**Seattle
Design
Commission**

**Approved
MINUTES OF THE MEETING
2 November 2006**

Projects Reviewed

Mercer Corridor Replacement Project
Ship Canal Bike Trail Extension
Capitol Hill Water Quality Improvement Project
New Rainier Vista – 31st Ave S.
Big Projects/Upcoming Projects
Alaskan Way Viaduct/Seawall Replacement

Pedestrian Connections

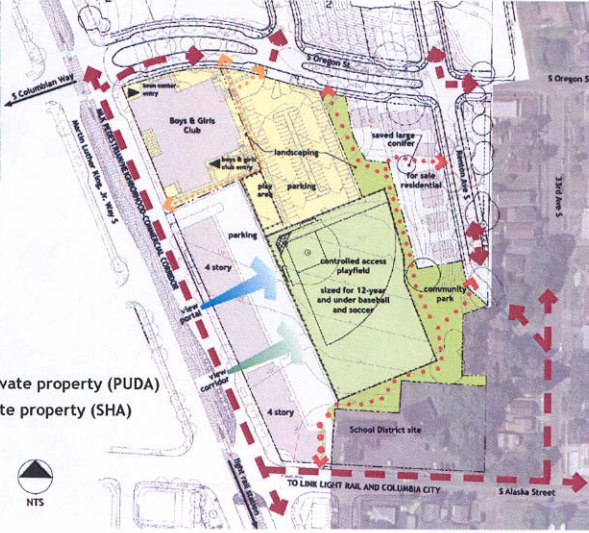
- Concerned about the view corridor. Can they really see in? Is there pedestrian permeability and what is the public feel and character of the open spaces? We thank the team for ways to get the pedestrian through the site, and as a pedestrian I can see myself moving through the site, but in some areas it feels a little scary. If I were to put water in any part of the site, what route would the water take down through the site? That's how pedestrians move.

- Concerned about the pedestrian path due east of playfield. A recommendation: bring the trail through the parking lot and playfield and make it more public. It would feel much safer. Otherwise, people will cut through to get to the light rail station.

- Not convinced that this is adequate open space east of the playfield, and the leftover spaces don't really add up. The spaces seem impenetrable. Make it feel safer and more open. There is an opportunity for leveraging open space more than you are already doing. The big concern is the fence between the playfield and the open space. Is there a different way to demarcate this space? A lower fence would be better.

- It's been lowered from 16-20', now it's 8'.
- Break down the wall! An 8' fence will not keep people out at night. A 4' fence would make us all psychologically feel more comfortable. The shape of circulation, a compromise on the building and parking would make this a more successful pedestrian link. As it is, circulation is through the parking lot. PUDA needs to be more successful public space.

- Appreciate the positive east west connection. A strong north south connection has been achieved with this presentation.
- The space behind playfield may prove a real security issue.

Alaskan Way at University Street with the Tunnel

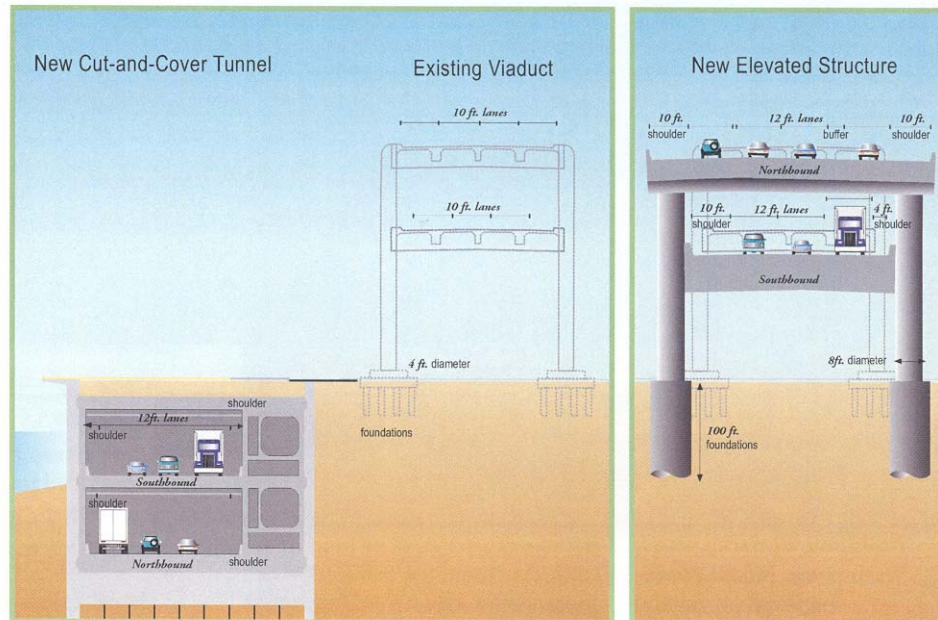
- We would like to see a perspective looking from downtown to the waterfront.
 - Stills (simulations) are in EIS and are available looking East West without the viaduct.
